September 16, 2019
BOARD OF COUNTY COMMISSIONERS
ORANGE COUNTY, FLORIDA
Y20-703-RC / ADDENDUM NO. 3
CONSTRUCTION OF ORANGE COUNTY FIRE STATION #87

This addendum is hereby incorporated into the bid documents of the project referenced above. The following items are clarifications, corrections, additions, deletions and/or revisions to, and shall take precedence over, the original documents. Underlining indicates additions, deletions are indicated by ~~strikethrough~~.

• sheet title
**INTERIOR
 FINISH LEGEND**

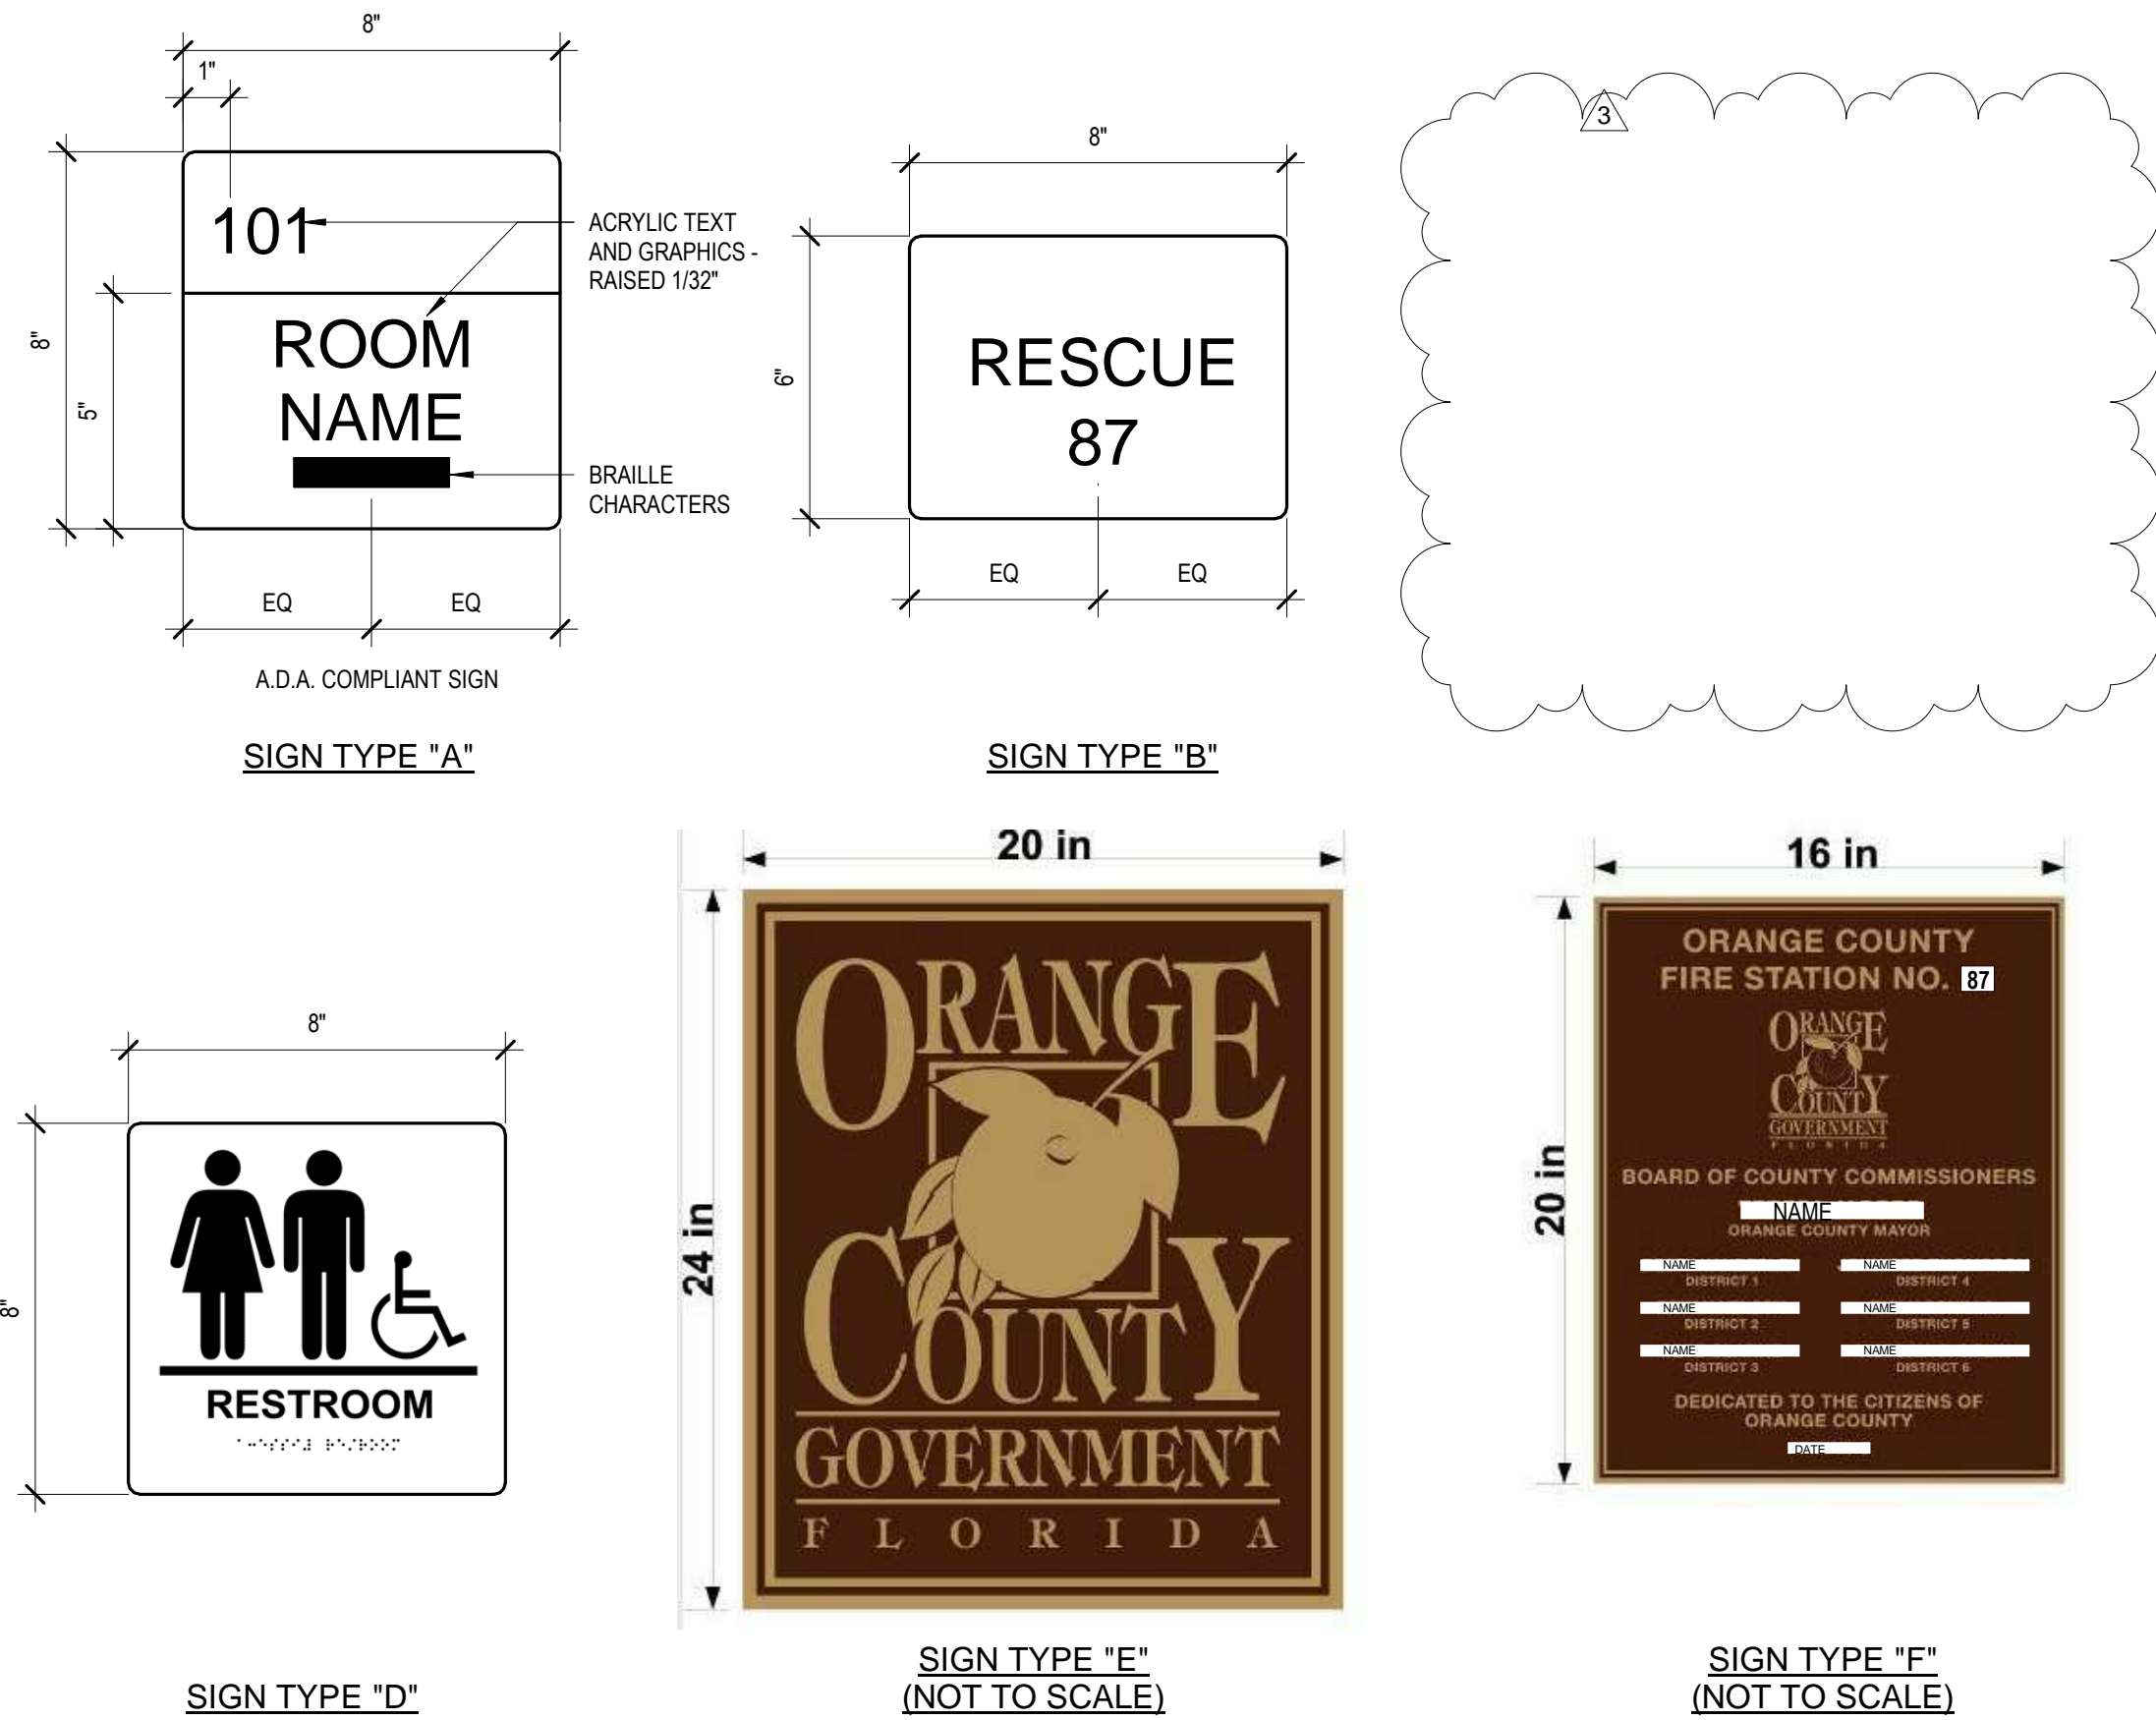
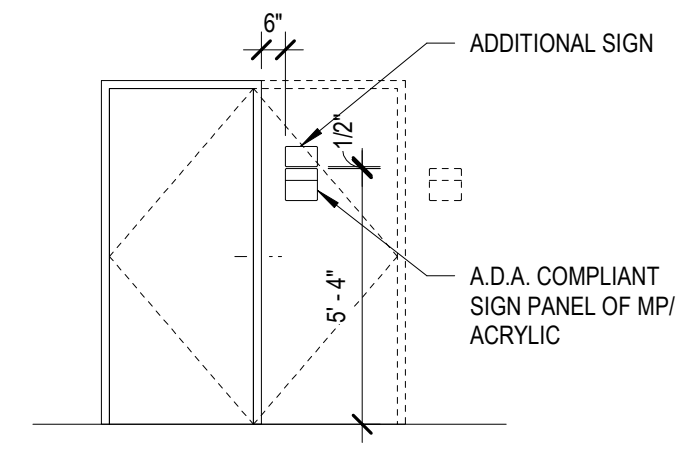
8. **Question:** GM-1 glass tile from Somer tile, looked on-line and cannot find they style designer selected for pricing. Please advise.

Answer: Alternate tile: Susan Jablon Tile, 2x2 Deep Tomato Red Glass tile, SKU: 5715796. Sheet ID-401 Interior Finish Legend revised and re-issued.

1 SIGNAGE TYPES

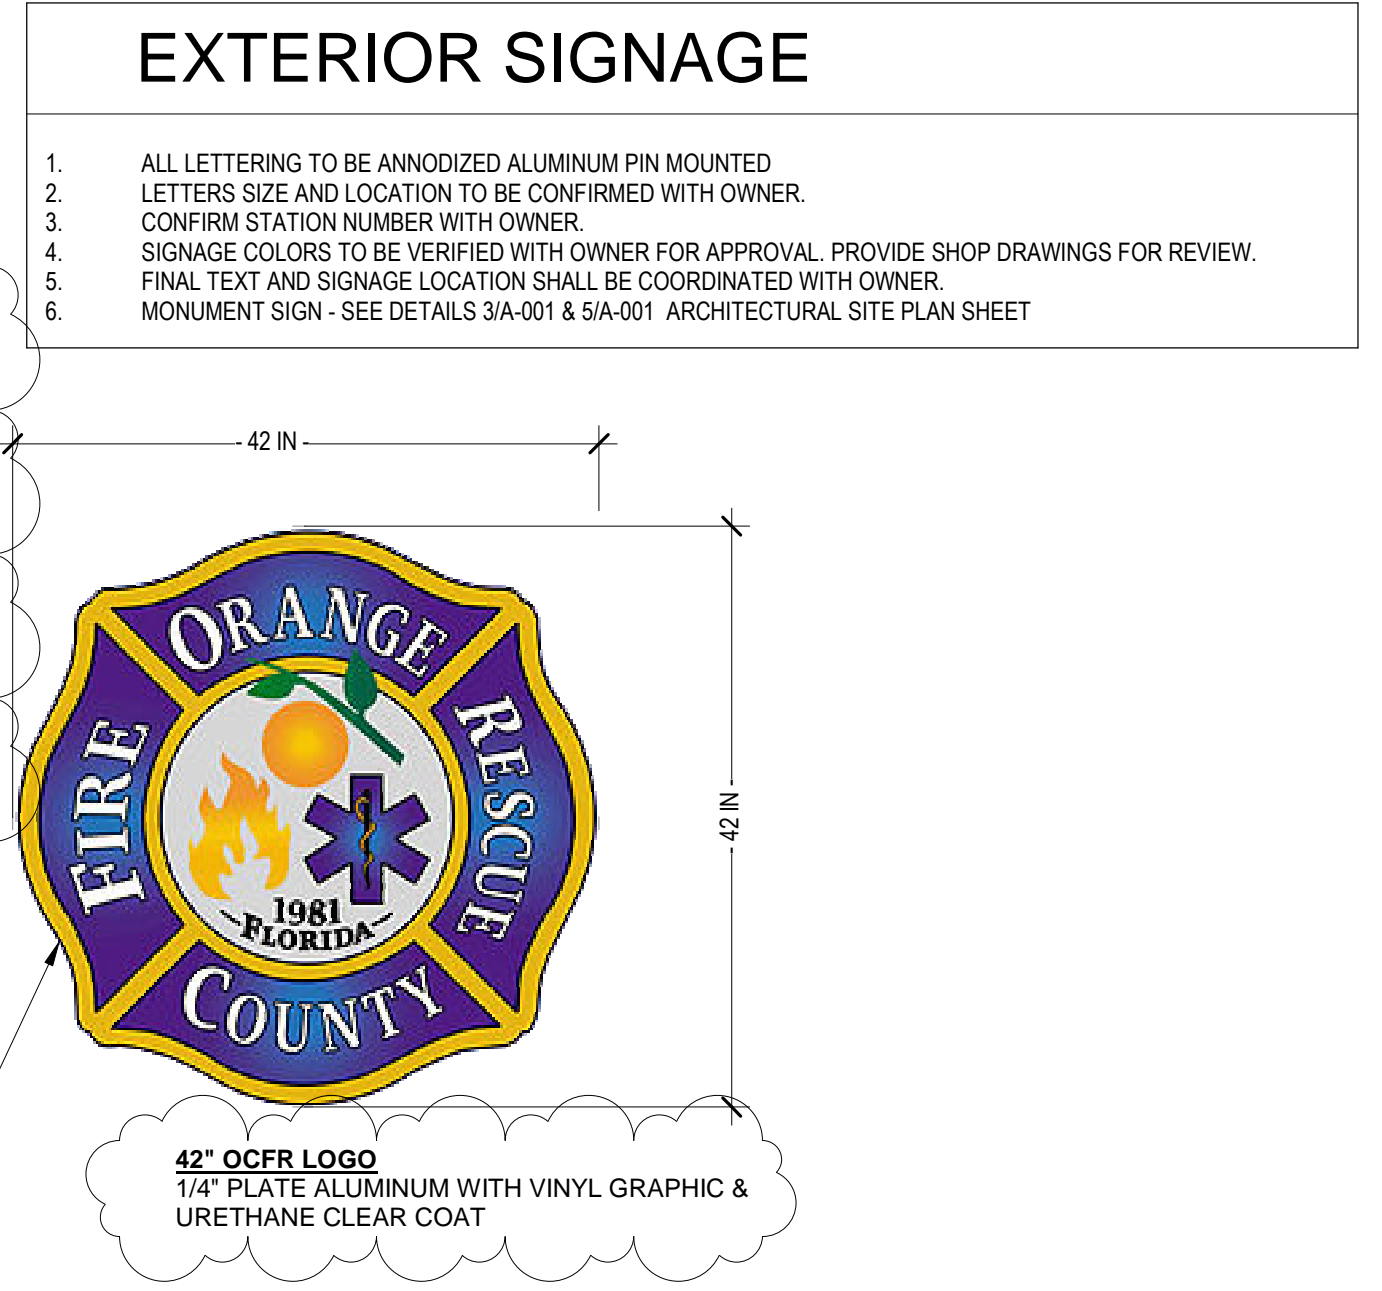
Answer: Sheet A-010 revised for additional clarity.
 3. **Question:** Sheet ID-500 42" Diameter Cast Aluminum Custom Logo: Anodized, Giclee Print? Or Custom Painted full color logo? Pin mount (Manufacturer: Gemini).

4. **Question:** Type C: 8"x6"x1/8" thick Acrylic sign with raised text and graphics; tape mount (manufacturer: Advance Corp) Are these used? Not in schedule. How many?

15. **Question:** The ADA schedule does not list a sign at every door/ room. Please confirm we are to bid ADA signs as scheduled not per door.

16. **Question:** Please provide spec for the 42" Dia logo on the wall and the 18" Dia logos on the monument. Is this a 1/4" cut alum with digital print? Is it cast alum with full paint? Other? Please specify.

Answer: Logo to be 1/4" plate aluminum with vinyl graphic & urethane clear coat. ID-500 revised. E-101 revised to show power to sign.

Answer: Sign Type C not used in project. ID-500 revised.

Answer: Please bid signs per sign schedule revised ID-500.

Answer: Logo to be 1/4" plate aluminum with vinyl graphic & urethane clear coat. ID-500 revised.
